**RE: PALEN SOLAR PROJECT AMENDMENT (09-AFC-7C)  
DATA REQUEST SET 2 (Nos. 19–39)**

**PALEN SOLAR POWER PROJECT (09-AFC-7C)  
DATA REQUESTS – SET 2**

**CULTURAL RESOURCES - FIGURE 1**  
Palen Solar Electric Generating System - Initial Staff Project Area of Analysis (PAA)

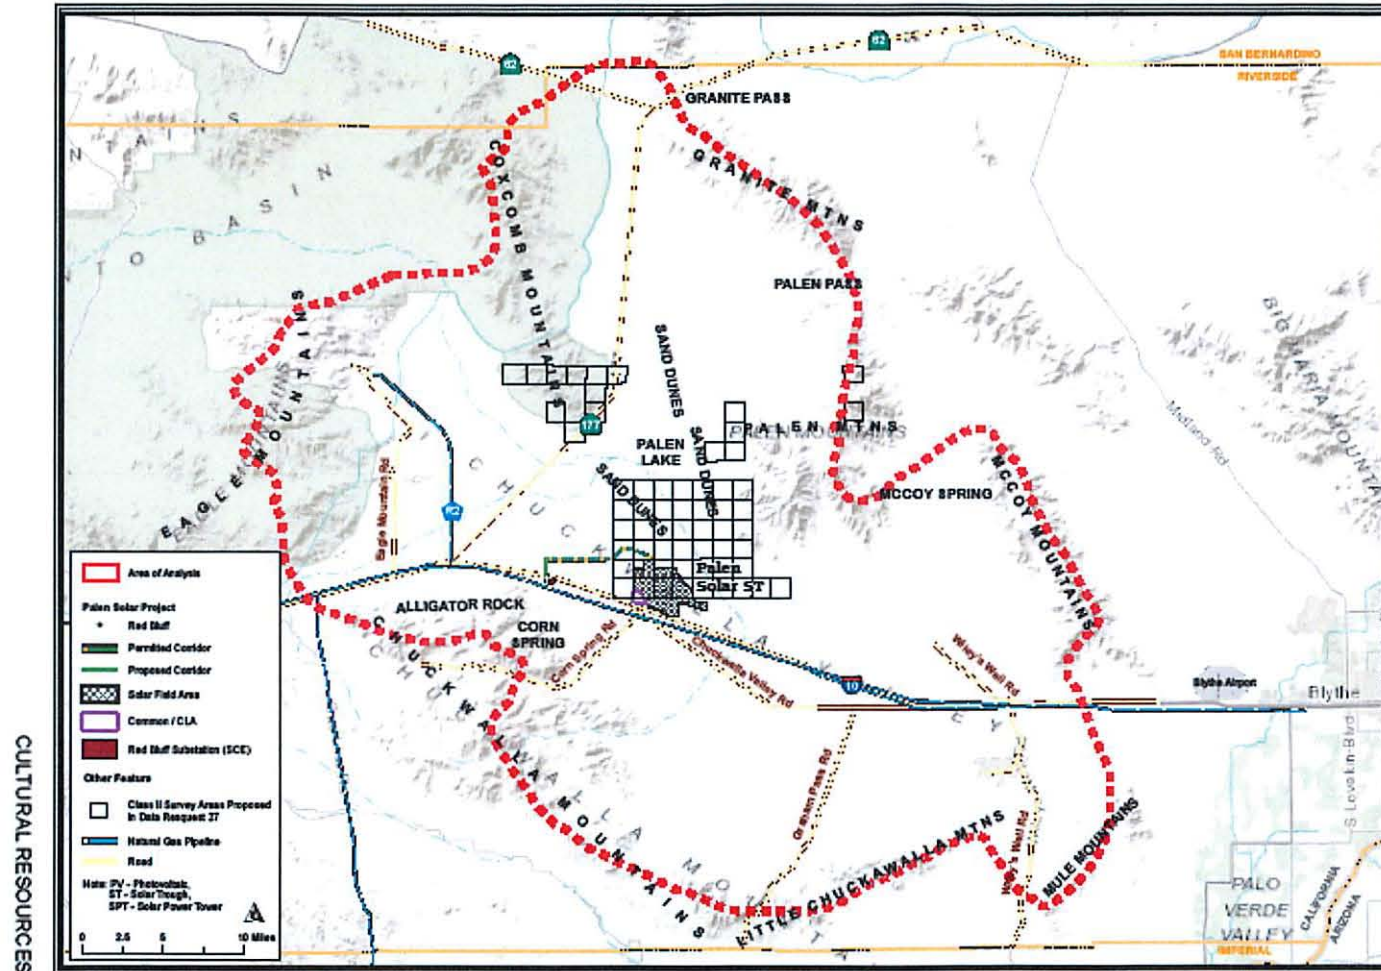
The project description included in the Petition for Amendment (PSEGS 2012) states that the project will no longer use the parabolic trough technology, as originally licensed, but will instead use solar power towers, associated power blocks, and heliostat fields. After review of the petition and a site visit to the project site and surrounding area, staff has determined that the previous PAA is not adequate to analyze the potential effects that could occur, given this change in technology. Specifically, switching from relatively low profile parabolic troughs to two, 750-foot tall power towers has the potential to affect cultural resources much farther away; therefore, the PAA clearly needs to be expanded. Staff has observed in the field that the project will be plainly visible from at least 12 miles away. Therefore, staff has determined that, in order to adequately evaluate the new potential effects of the amended project, the revised PAA should probably include all visible areas within approximately 15 miles of the project area boundary. Staff believes that this would constitute the geographic area across which the project may have the potential to cast significant visual effects on cultural resources. Figure 1 is a rough approximation of this area. The archaeological, ethnographic, and built-environment components of the PAA for the amendment vary with respect to the differences in the character of the inventory for each of these resource types and are addressed separately below.

21. Staff has sketched out, in relatively broad strokes, a preliminary concept of what staff believes is the appropriate PAA for the proposed project. Please refine the concept that staff has set out, both above and below, adjust it on the basis of explicit argumentation, and plot out the boundaries of the project owner's iteration of the resultant PAA on a map of no less than a 1:24,000 scale. The project owner's iteration should include a delineation of the original project boundary and the new project boundary. Those areas from which the power towers will not be visible may be eliminated from the approximate 15-mile radius depicted in Figure 1. Please provide explicit justifications to support areas eliminated in this manner. The PAA is and will remain the fundamental basis for all subsequent requests for information related to the potential effects of the amended project on cultural resources. Staff's preliminary reiteration of it here is the foundation for the present cultural resources data requests. If the project owner's concept of the PAA differs significantly from staff's, staff would encourage the project owner to notify staff and, at the earliest possible date, seek to publicly resolve any substantive differences of opinion.
